**DEPARTMENT OF TRANSPORTATION
STATE OF GEORGIA**

FILE: STP-IM-180-1(6) Catoosa **OFFICE:** Engineering Services
P. I. No.: 621530-
I-75 @ S.R. 151 Interchange
DATE: April 7, 2008

SUBJECT: IMPLEMENTATION OF VE STUDY ALTERNATIVE - REVISED

SUBJECT VALUE ENGINEERING ALTERNATIVE

VE ALTERNATE

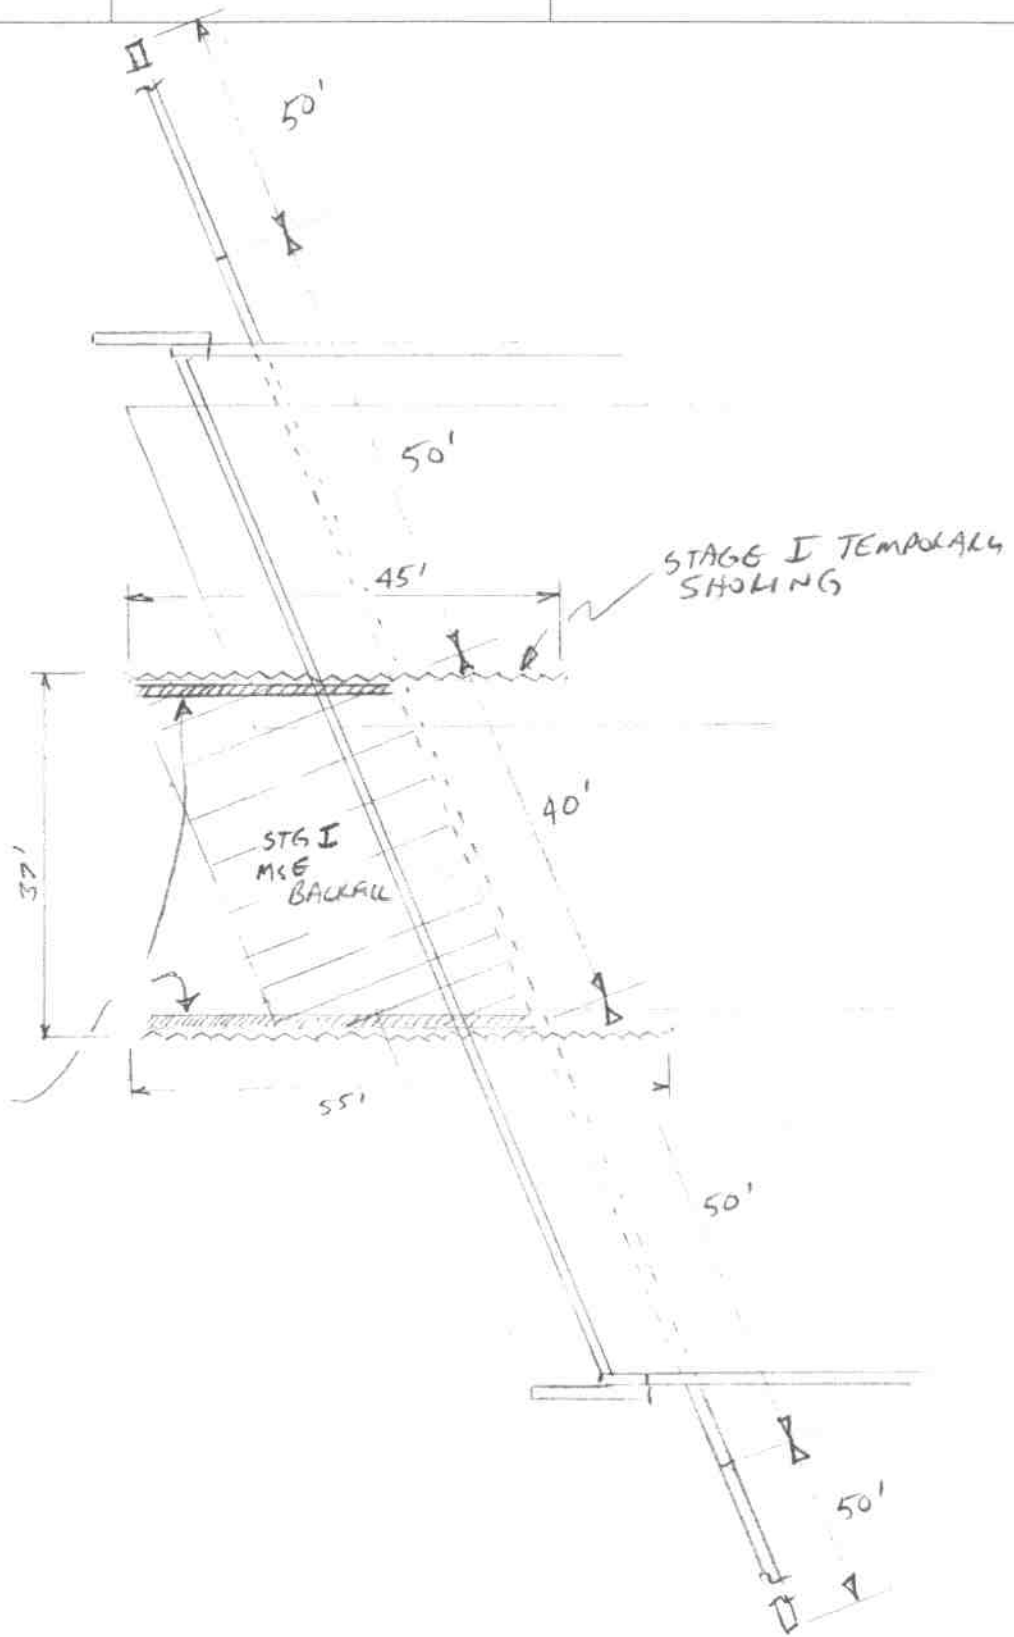
Alternate B-9, as stated in the Implementation of Value Engineering Study Alternatives dated September 7, 2007, recommends using MSE abutment walls for the construction of the SR 151 bridge over I-75. The study estimates the potential cost savings for this alternative as \$706,703. The Bridge Office has re-evaluated the estimate for this work and has determined that implementation of this alternative will result in an increase of \$10,036 over the original design, see attached estimate. The change in estimate is primarily driven by the additional shoring required in order to construct the middle stage of the MSE abutment walls at each end of the bridge. In addition, the VE estimate for this alternative had a mathematical error of \$314,820.

$$\text{SHORING} = (32' \text{H}) (45' \text{L} + 55') (20 \text{ \$/SF}) = 64,000$$

$$\text{TEMP. MSE} = (32' \text{H}) (30' \text{L} + 17' \text{L}) (15 \text{ \$/SF}) = 22,560$$

$$\text{ADD. MSE BACKFILL} (7') (25') (130') (1/27) (185 \text{ \$/cy}) = 155,890$$

$$2 \text{ ABUTMENTS} \times 2 = 1,103,194$$

$$-10,036$$
